Effect of pattern length on apparent peak-to-peak voltage

IEEE P802.3bm, Jan 2014, Indian Wells

- Comment 137
- The apparent peak-to-peak differential output voltage of the host depends on the pattern used, because the host channel and HCB have loss and the signal is under-emphasised where observed. Also it is better to **have a spec that relates consistently to voltage swing at the IC**, so there is no need to set up the swing port by port.
- **PRBS9 is too short** for consistent measurements across different host losses.
- Define suitable patterns for peak-to-peak differential voltage: any of PRBS15, PRBS31, scrambled idle, RF, any other 100GBASE-R signal (FEC encoded or not).

- Subclause: 83E.3.1.2 Signal levels
- Page 166, Line 42

Example channel vs. C2M CAUI-4 insertion loss budget

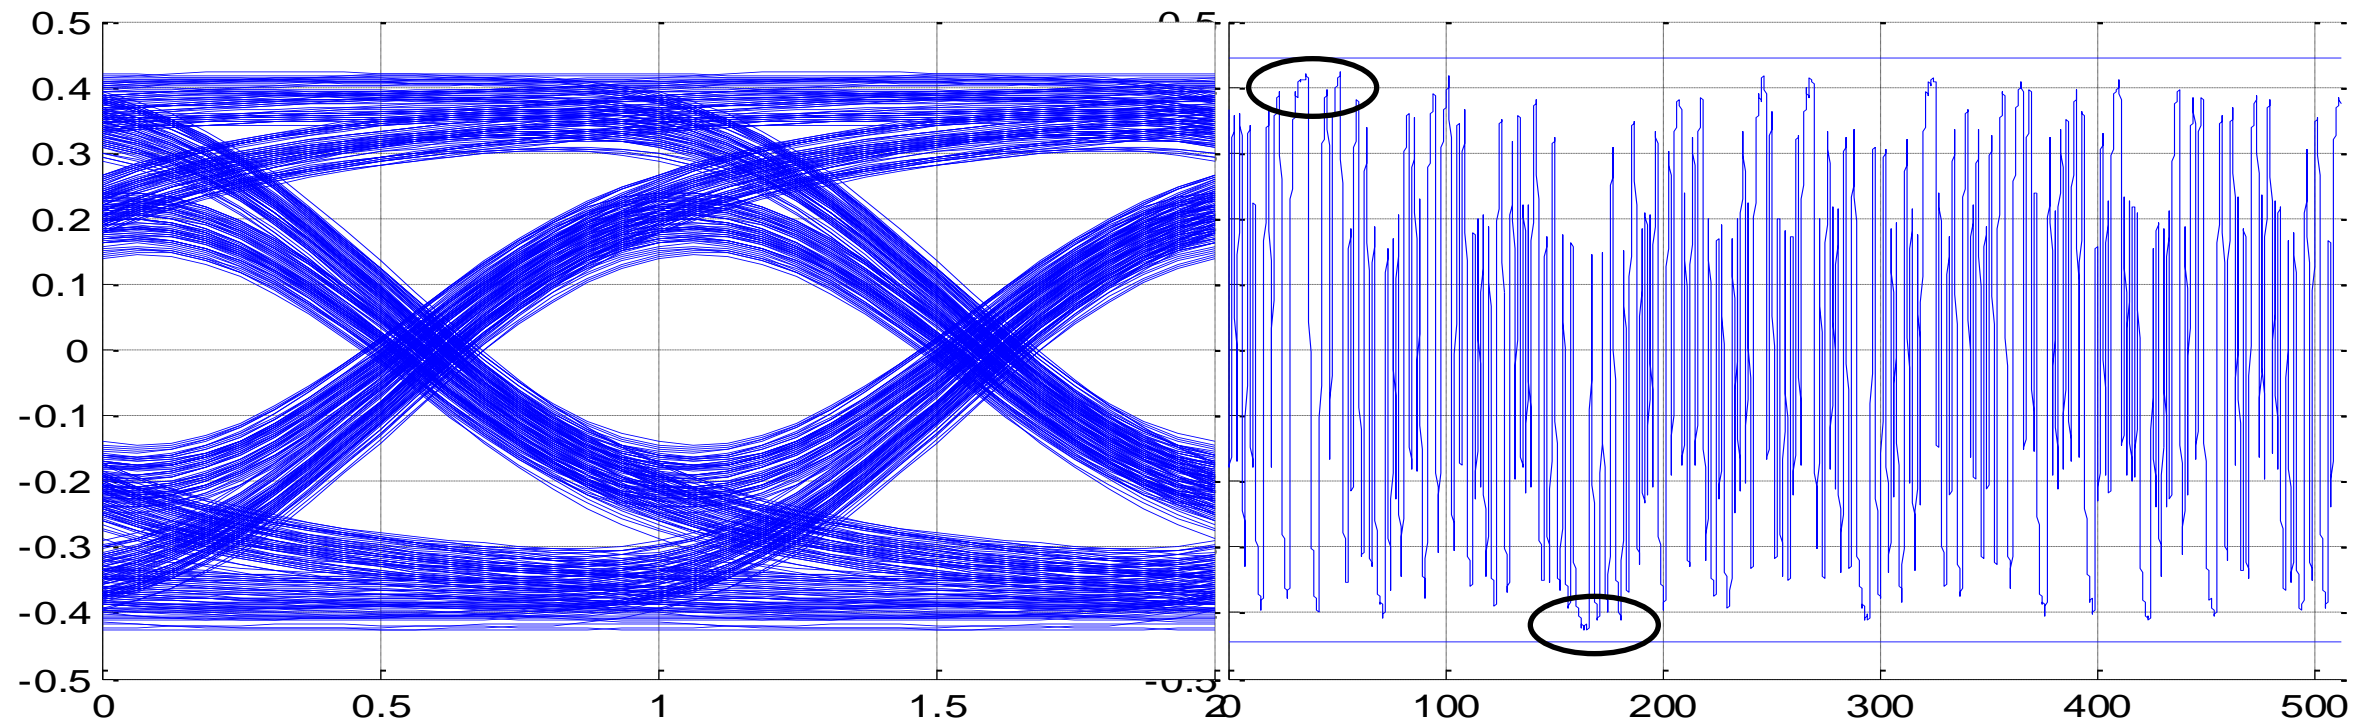
- Signalling rate 28 GBd
- Channel is Sdd21 of oif2010_407 *
 - This is not worst case
 - Should include IC package response
 - Minimum SDD21 is only a recommendation; implementers will try for more loss
- DC response of this channel is 0.987 or -0.12 dB

Peak-to-peak voltage depends on pattern

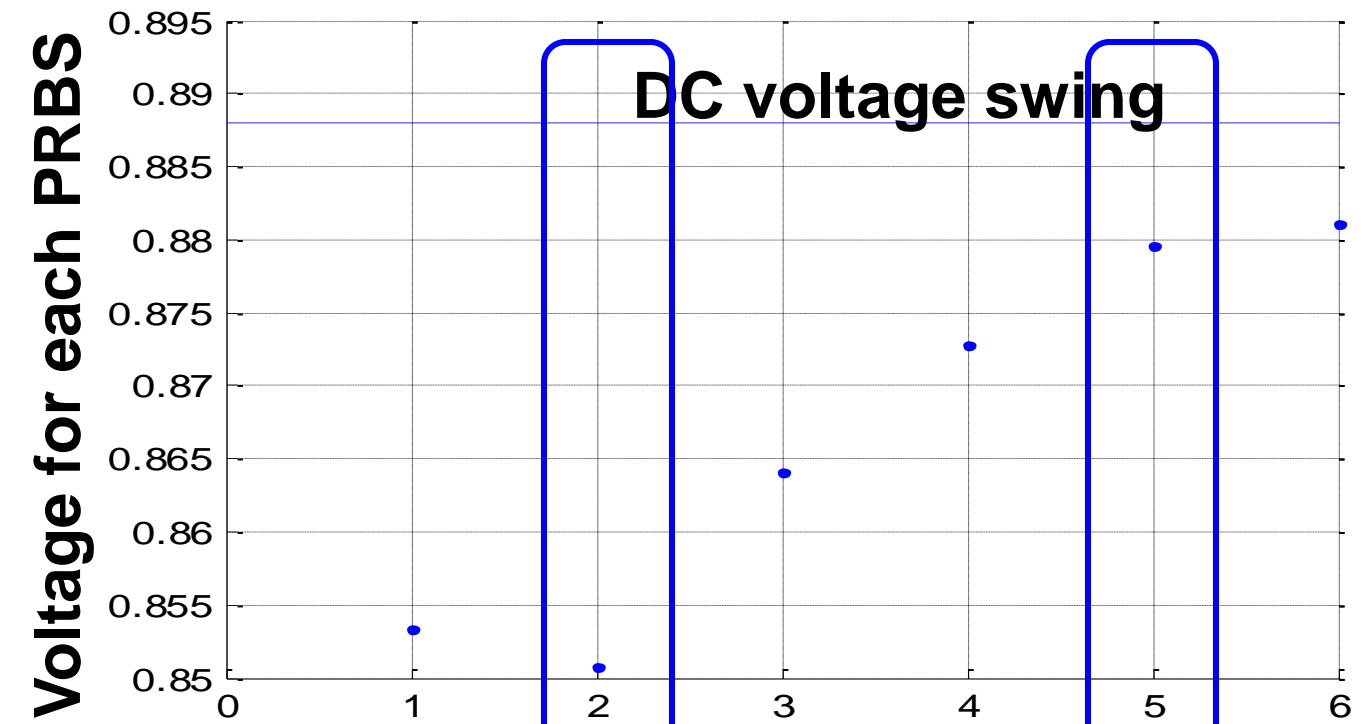
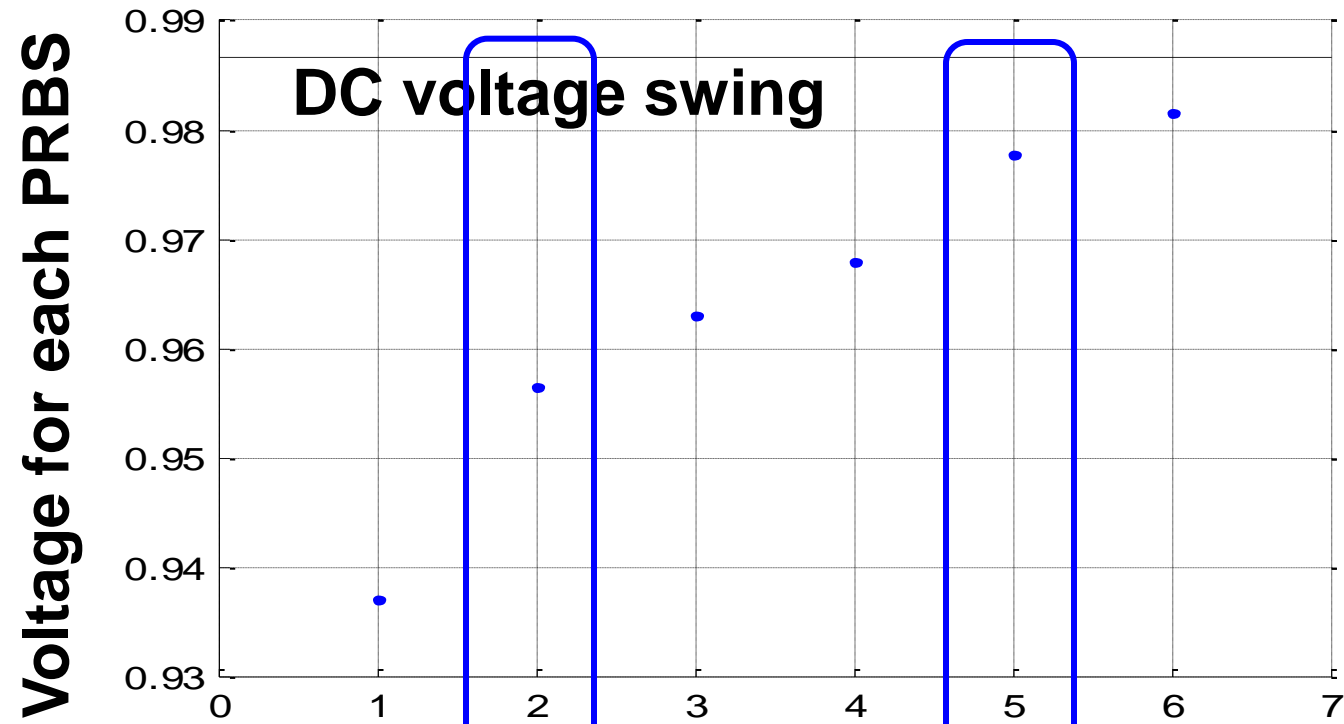
- Left and right input signals differ
- Left: 25.78125 GBd Right: 28 GBd
- 3% to 4% error with PRBS9 in these cases
- Host IC package loss and any more host channel loss will increase this – maybe 5%
- Going to PRBS15 reduces this to about 1%

Is the peak-peak voltage clearly defined?

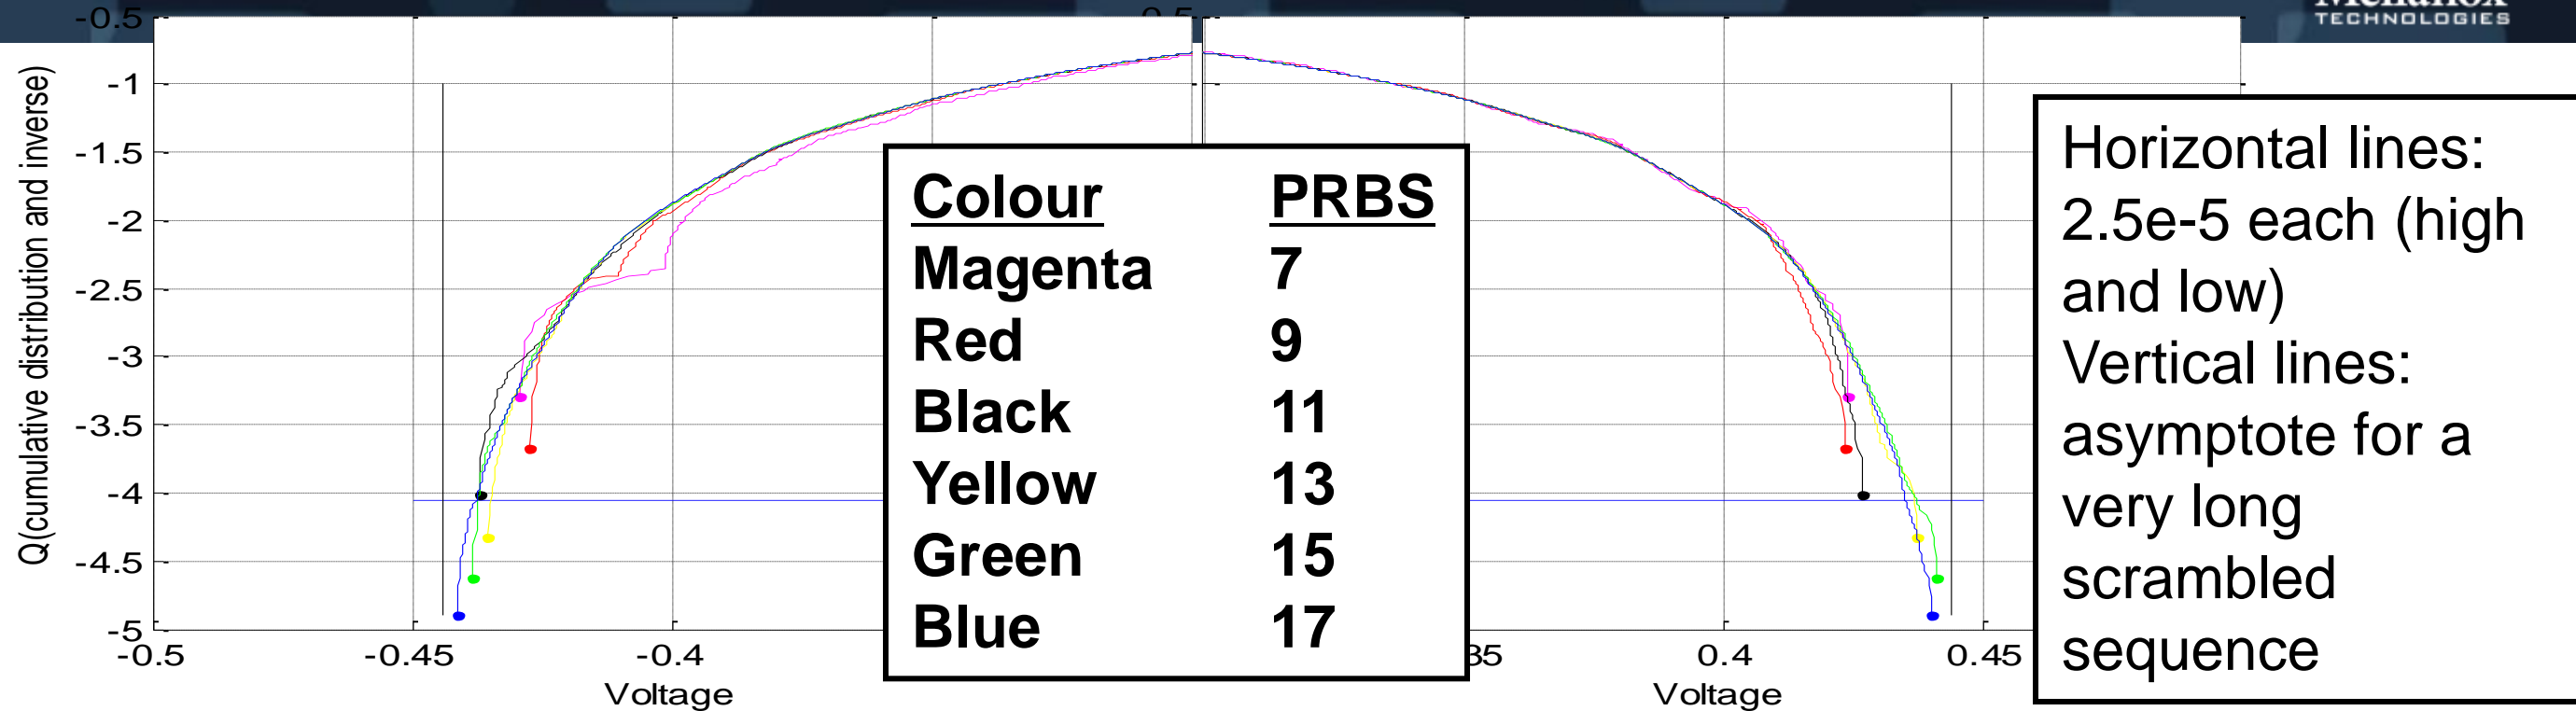
- PRBS7 to PRBS11 are too short to find the in-service peak-to-peak voltage with user data not a test pattern
 - Note the "PRBS end effects": the extremes of the curves are rough
- In this case, PRBS13, 15 and 17 give very similar results
- Measuring to the usual mask hit ratio of 5e-5 would give consistent results from a quick measurement with PRBS15 or longer (e.g. PRBS31)
 - More practical than original pk-pk on PRBS31
 - More accurate than PRBS9
